City Planning Commission  
Sacramento, California

**Subject:** Appeal of Design Review Board's denial of the proposed "Tea Cup Cafe",  
1614 - 21st Street (DR87-165).

PROPOSAL: The applicant proposes development of a 81 seat restaurant (Tea Cup Cafe).

# SITE PLAN

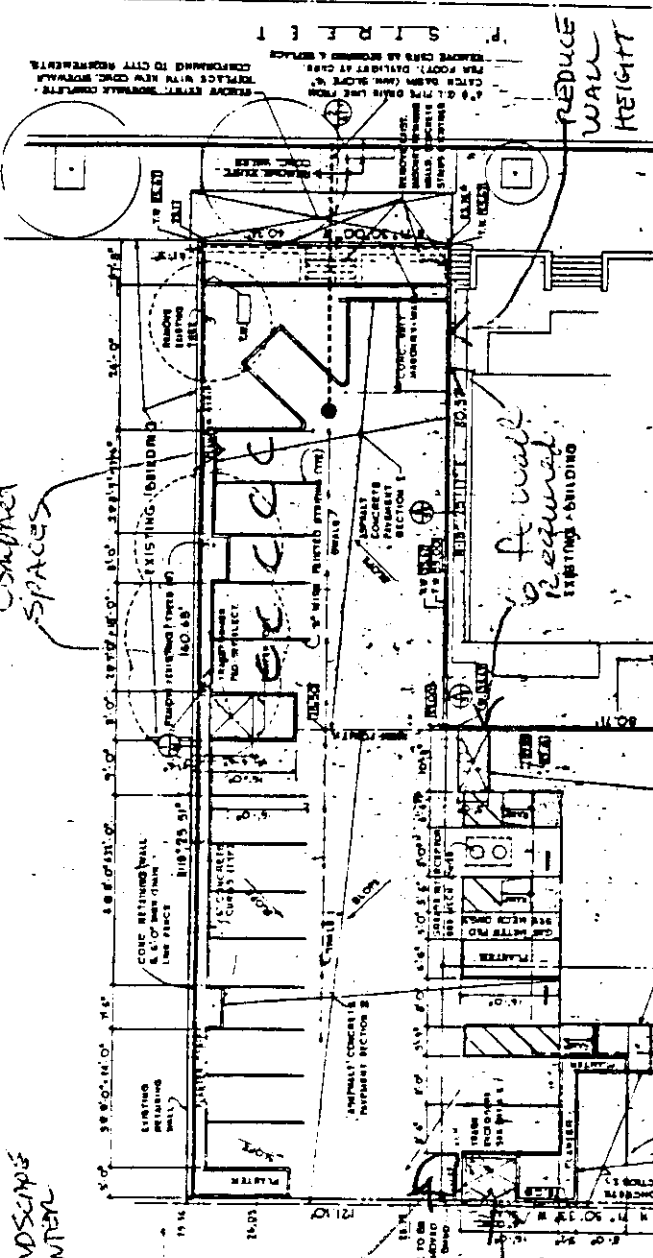
The revised plans provide for end planters fronting the alley, increased landscape width along P Street that will compensate for the parking area being elevated and a planter in front of the building on 21st Street. The setting back of the building to accommodate the planter on 21st Street also facilitates retaining the roof without it having to be a visually obtrusive projection over the public right-of-way.

2. The parking lot frontage on P Street is increased in width and a terracing will provide a transition between the sidewalk and higher parking lot level. A wall at the back edge of the landscaping and along the interior property line shared with the existing residential use that abutts to the east, will serve to screen the parking lot surface and parked vehicles. The wall placement and the planter width had been determined to coincide with the top step of an existing set of steps on the adjacent property.

3. The three parking spaces closest to P Street are marginally acceptable to Traffic Engineering. Vehicles would have to be backed out to the alley or to another vacated space for turning around.
4. Although a two-story structure would be more compatible with the existing two-story structures in the area, the submitted building design, is otherwise acceptable to staff.
5. The west side of the trash enclosure should have planter space to provide a softening effect to the masonry wall. The masonry should be brick to match the building. For durability, a full brick rather than veneer and a heavy ribbed metal gate would be appropriate.

1. Final planter and wall design on P Street shall be subject to staff review and approval.

2. The trash enclosure shall be brick to match the main structure. A full brick rather than a veneer shall be used. The enclosure gates shall be of heavy ribbed metal plating. Additional planting shall be provided on the west side of the enclosure. Revised plans shall be subject to review and approval by staff.

WEST ELEVATION  
 SCALE: 1/4" = 1'-0"

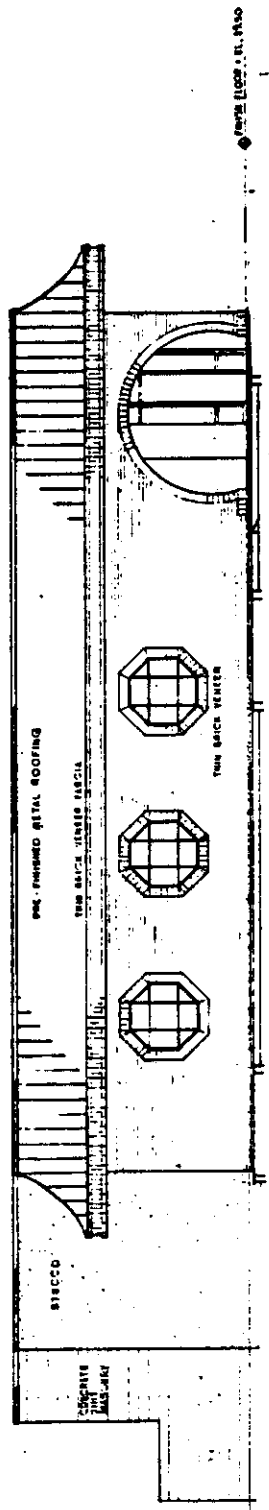
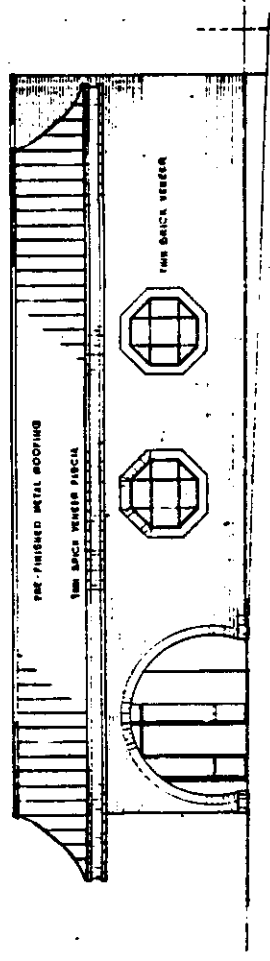
1. The project was too large for the site.
2. The project is not compatible to the area and the streetscape.
3. The project is poorly sited in relationship to the existing building to the north.

1. The project would be better suited to the site and the streetscape if redesigned.
2. The applicant having completed the working drawings prior to design review is not sufficient reason to approve the project.

Staff recommends the City Planning Commission deny the appeal and instruct the applicant to return to the Design Review Board with revised drawings to meet the Board's concerns.
